Addendum #2 **Huntington City Building Façade Repairs**

Date: June 24, 2015
Project: Huntington City Building Façade Repairs
Pages: 3 pages
Bid Dates: **June 27, 2016**

1. An existing floor plan is provided for scale purposes only, 11x17 sheet

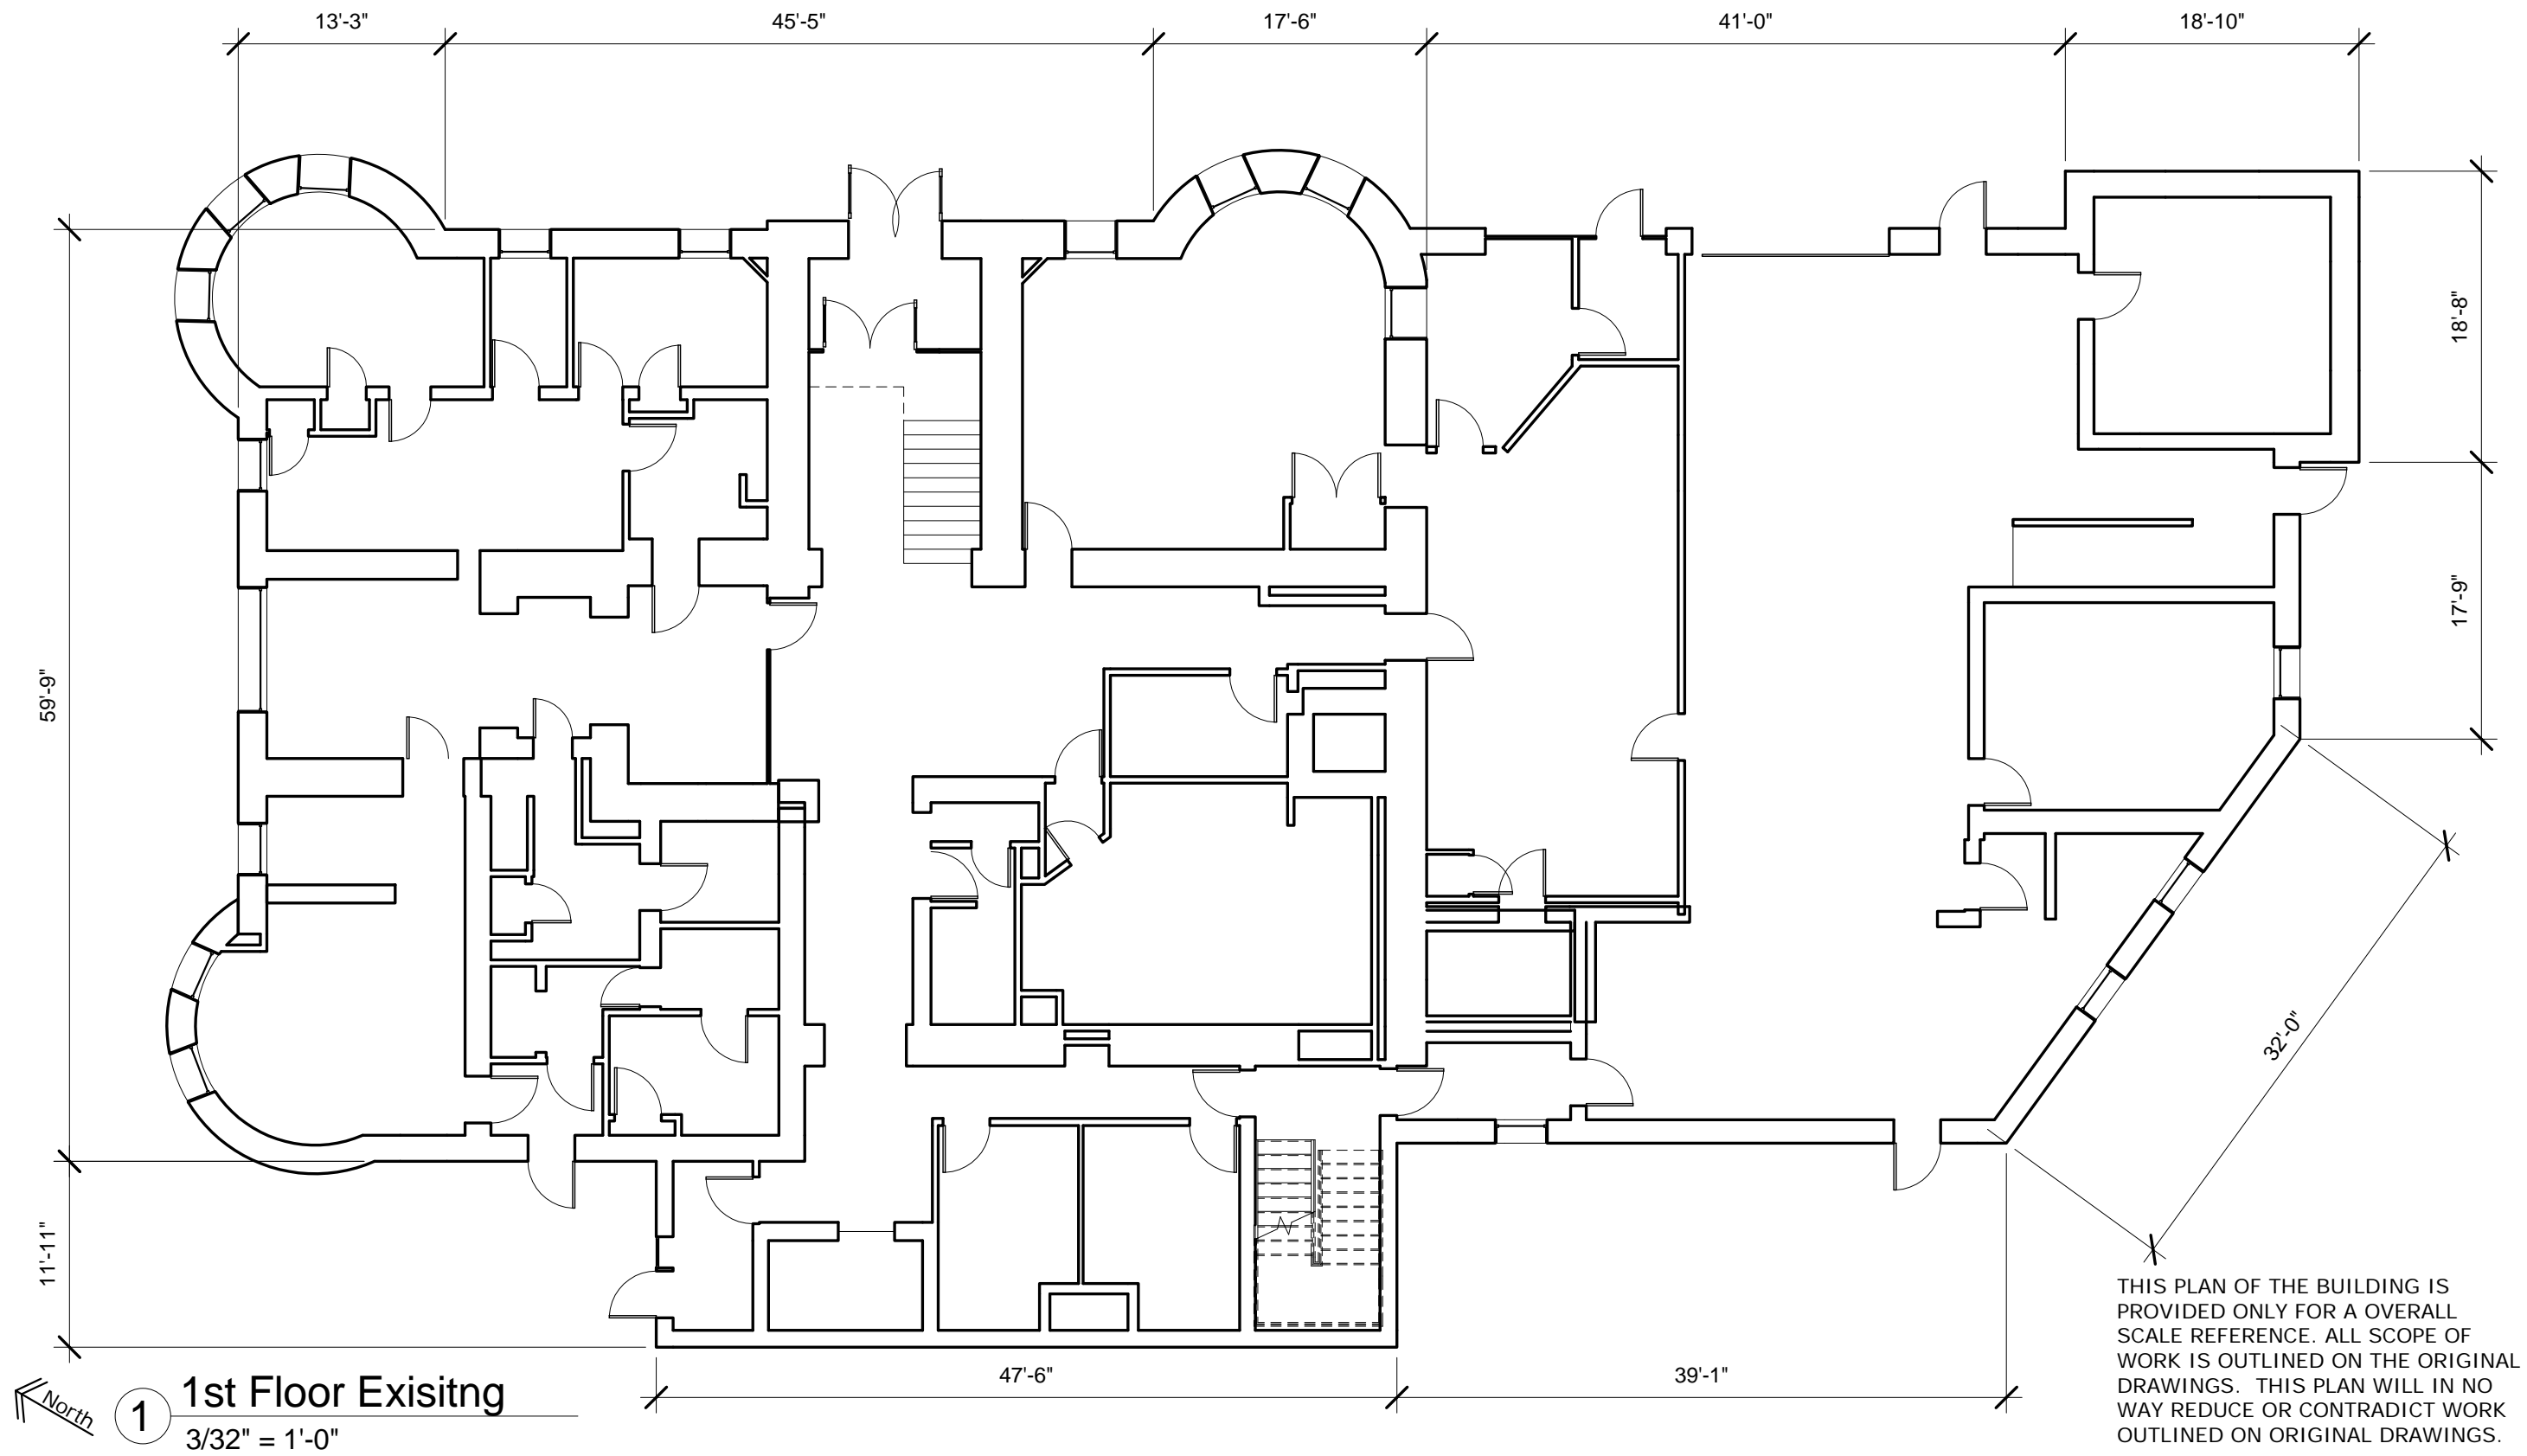
1. While scale elevations can not be provided to a detail level that would be helpful rather than create confusion, we are able to provide a basic floor plan to scale for a reference, see attached.
 2. At west elevation, note 'J', the work will be similar to that shown in detail 2 on R100 but the veneer will be brick rather than stone and the heights will be different.
-
